# Access Audit Site Report

**Hill Country State Natural Area**  
**10600 Bandera Creek Rd**  
**Bandera, TX 78003**  
**Accessibility Evaluation**  
**Inspection Date: 03/23/2022**  
**Inspectors: Tanya Scheibe**

**TEXAS PARKS AND WILDLIFE DEPARTMENT  
HILL COUNTRY STATE NATURAL AREA**

**AMERICANS WITH DISABILITIES ACT COMPLIANCE INITIATIVE  
PROGRAM AND POLICY REPORT  
JULY 28, 2023**

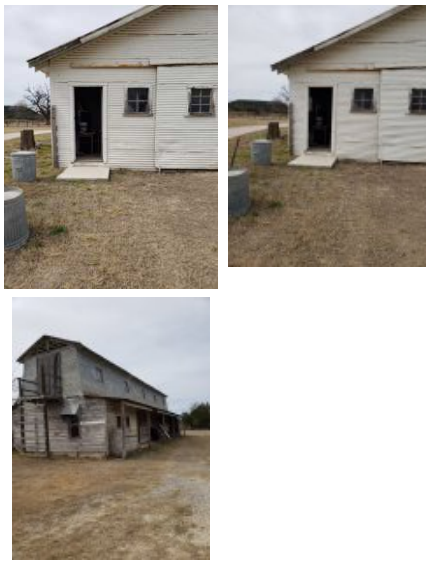
Finding Number	Area Description	Lat/Long	Finding	As Built	Recommendation	Citation	Photos	Figure
35	Employee Areas: Maintenance	[29.625387, -99.174415 4]	The operable part is not accessible because there is not adequate clear floor space for either a forward or side approach. The clear floor or ground space shall be 30 inches minimum by 48 inches minimum.	hilltop break room- no clear floor space for microwave due to storage and furniture	Remove, or relocate storage in CFS at fixtures and operable parts along the AR	2015 ABAAS Section: 305.3 2012 TAS Section: 305.3 2010 ADAS Section: 305.3		
36	Employee Areas: Maintenance	[29.625408, -99.174423 4]	The top of the work surface is not within a compliant height range. The tops of tables and counters shall be 28 inches to 34 inches from the floor or ground.	hilltop break room- only table does not provide knee and toe clearance	Provide tables and work surfaces at 28" to 34" aff with required knee and toe clearances	2015 ABAAS Section: 902.3 2012 TAS Section: 902.3 2010 ADAS Section: 902.3

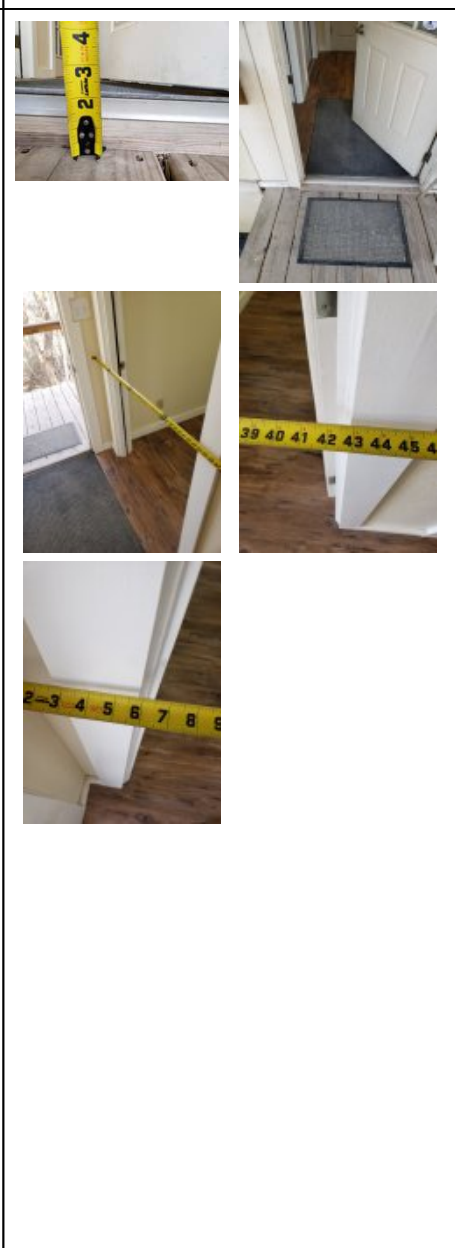
64	Headquarters Area: HQ - Public Spaces	[29.6280426 , -99.181118 2]	The transaction counter is too high. A portion of the counter surface that is 36 inches long minimum and 36 inches high maximum above the finish floor shall be provided. Knee and toe space must be provided for a forward approach. A 30 inch by 48 inch clear floor space on an accessible route must be provided for either a forward or parallel approach.	41" above finished floor	Lower 36" wide segment of service counter to max 36" aff	2015 ABAAS Section: 904.4.2, 904.4.1 2012 TAS Section: 904.4.1, 904.4.2 2010 ADAS Section: 904.4.2, 904.4.1

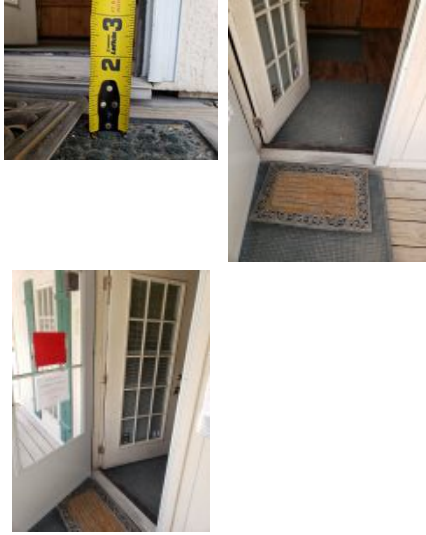
67	Headquarters Area: HQ - Public Spaces	[29.6280473 , -99.181112 9]	The operable part is positioned too high for either a side or front approach. Where a clear floor or ground space allows a parallel approach to an element and the side reach is unobstructed, the high side reach shall be 48 inches maximum and the low side reach shall be 15 inches minimum above the finish floor or ground. Where a forward reach is unobstructed, the high forward reach shall be 48 inches maximum and the low forward reach shall be 15 inches minimum above the finish floor or ground.	Top row of maps only available over 48" above finished floor	Remount operable parts to be in reach range of 15" min to 48" max	2015 ABAAS Section: 308.1 2012 TAS Section: 308.1 2010 ADAS Section: 308.1

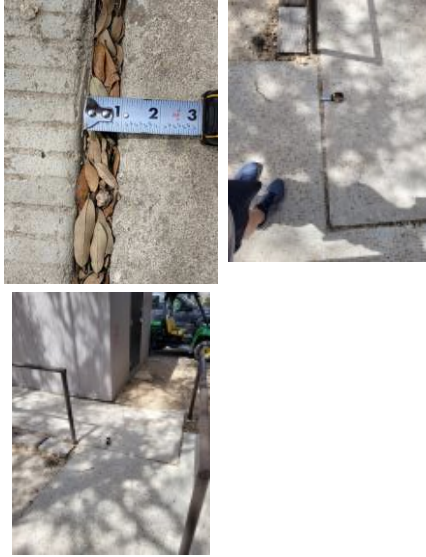
Finding Number	Area Description	Lat/Long	Finding	As Built	Recommendation	Citation	Photos	Figure
70	Headquarters Area: HQ - Employee Spaces	[29.6280449 , -99.181118 2]	Minimum maneuvering clearances at doors and gates shall comply with 404.2.4. Maneuvering clearances shall extend the full width of the doorway and the required latch side or hinge side clearance. The threshold has a vertical change greater than 1/4 inch high. Secure mat/carpet at door.	Rear door exterior- 2" change in level, loose mats on both sides, lacks maneuvering clearance on pull side	For all doors along the public circulation route, provide required maneuvering clearance on push and pull side of doors. For all doors along the public circulation route, repair, bevel, or ramp CILs at door entries to max .25". Secure mat/carpet at door.	2010 ADAS Section: 404.2.3, 404.2.7, 404.2.4, 404.2.11, 404.2.11 Exception

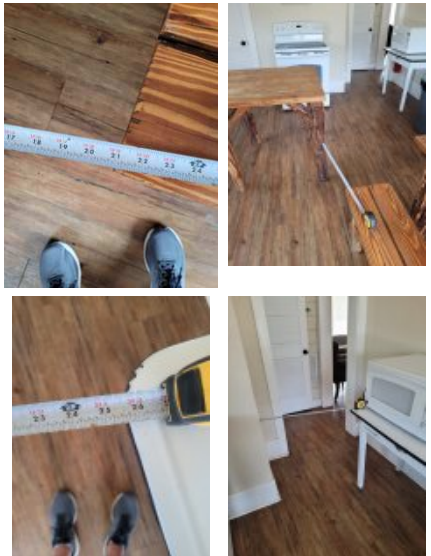
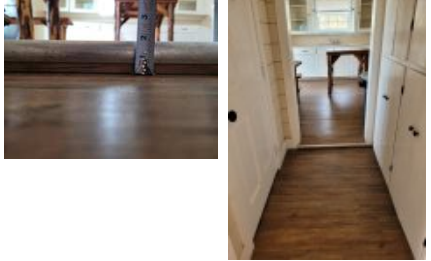
Finding Number	Area Description	Lat/Long	Finding	As Built	Recommendation	Citation	Photos	Figure
91	Trailhead Equestrian Camp Area: Trailhead Equestrian - Restroom	[29.6342026, -99.1848088]	Element meets all standards and requirements	Restroom door complies	None	2010 ADAS Section: N/A		
92	Trailhead Equestrian Camp Area: Trailhead Equestrian - Restroom	[29.634174, -99.1848082]	There is no accessible route to the restroom. At least one accessible route shall connect accessible buildings, accessible facilities, accessible elements, and accessible spaces that are on the same site.	lacks accessible route, 1.75" change in level	Create an accessible route with crushed stone or other outdoor material from parking or walkway to restroom.	2015 ABAAS Section: F206.2.2 2012 TAS Section: 206.2.2 2010 ADAS Section: 206.2.2

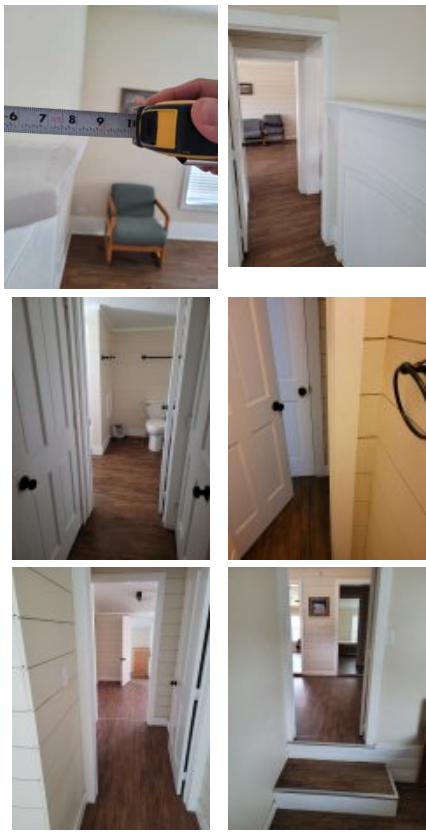
100	Group Lodge: Group Lodge - Public Spaces	[29.6485789 , -99.200121 7]	There is a change in level greater than 1/4 inch. 1/4 inch is the maximum vertical rise. Changes in level between 1/4 inch and 1/2 inch must be beveled at 1:2 or less. Changes in level greater than 1/2 inch must be by way of a ramp.	kitchen- 1.5" entering kitchen	Repair, bevel or ramp CIL along accessible route (AR) to max .25".	2015 ABAAS Section: 303.3  2012 TAS Section: 303.3  2010 ADAS Section: 303.3

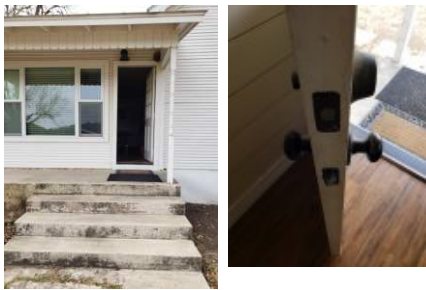
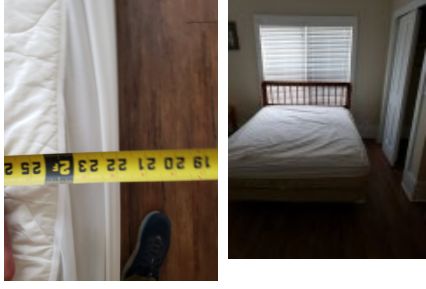
Finding Number	Area Description	Lat/Long	Finding	As Built	Recommendation	Citation	Photos	Figure
111	Group Lodge: Group Lodge - Public Spaces	[29.648601, -99.200115]	Minimum maneuvering clearances at doors and gates shall comply with 404.2.4. Maneuvering clearances shall extend the full width of the doorway and the required latch side or hinge side clearance.	8.5" shelf projection in push maneuvering clearance front bedroom 1; maneuvering clearance large restroom push; maneuvering clearance push small restroom; maneuvering clearance push front bedroom 2; maneuvering clearance on stairs on push back bedroom	For all doors along the public circulation route, provide required maneuvering clearance on push and pull side of doors.	2010 ADAS Section: 404.2.3, 404.2.7, 404.2.4, 404.2.11, 404.2.11 Exception		
112	Group Lodge: Group Lodge - Public Spaces	[29.6485824, -99.200129 7]	The route of travel at this location does not provide a minimum width of 36 inches. The clear width shall be permitted to be reduced to 32 inches minimum for a length of 24 inches maximum provided that reduced width segments are separated by segments that are 48 inches long minimum and 36 inches wide minimum.	rear bedroom- 26" between dresser and bed	Widen AR to compliant 36" clear width	2015 ABAAS Section: 403.5.1  2012 TAS Section: 403.5.1  2010 ADAS Section: 403.5.1

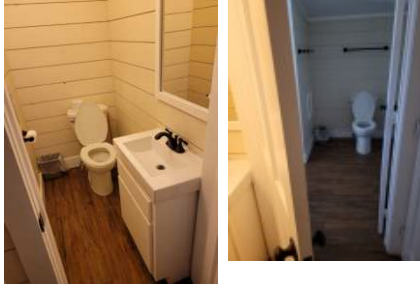
115	Group Lodge: Group Lodge - Public Spaces	[29.64858, -99.200129 7]	There is a change in level greater than 1/4 inch. 1/4 inch is the maximum vertical rise. Changes in level between 1/4 inch and 1/2 inch must be beveled at 1:2 or less. Changes in level greater than 1/2 inch must be by way of a ramp.	rear bedroom - 8" step to door	Repair, bevel or ramp CIL along accessible route (AR) to max .25".	2015 ABAAS Section: 303.3  2012 TAS Section: 303.3  2010 ADAS Section: 303.3

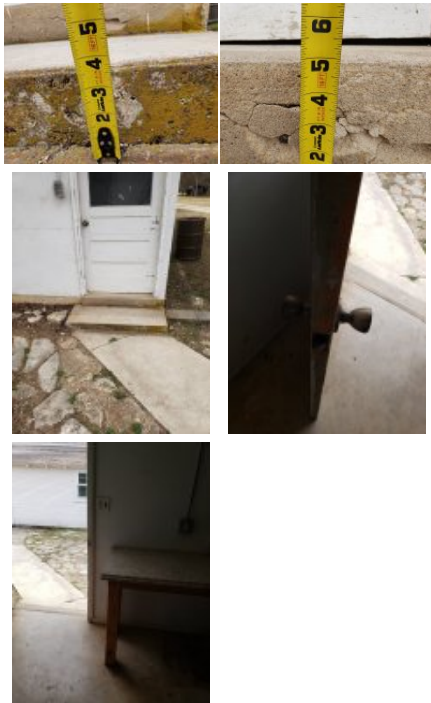
123	Group Lodge: Group Lodge - Restrooms	[29.6485789 , -99.200117 7]	50% of the single accommodation restrooms provided in this grouping are not nearly compliant. The restrooms do not have the required minimum clear floor space or maneuvering clearances for the toilet, The restrooms do not have the required minimum clear floor space or maneuvering clearances for the lavatory, The entry doors do not contain the required minimum maneuvering spaces on the pull/push sides, The entry doors encroach into the required clear floor space for fixtures, Grab bars are missing and/or incorrectly installed, Accessories, such as toilet seat covers, paper towel holders, garbage cans, hand dryers, and mirrors are either too high or without clear floor space or both, The restrooms contain floor level changes greater than a 1/2 inch, the showers are too small and missing numerous accessible elements.	small restrooms not accessible	Create compliant wheelchair accessible restrooms and correct all features to be accessible if feasible to meet 50% compliant restrooms in this location.	2015 ABAAS Section: 603.1  2012 TAS Section: 603.1  2010 ADAS Section: 603.1
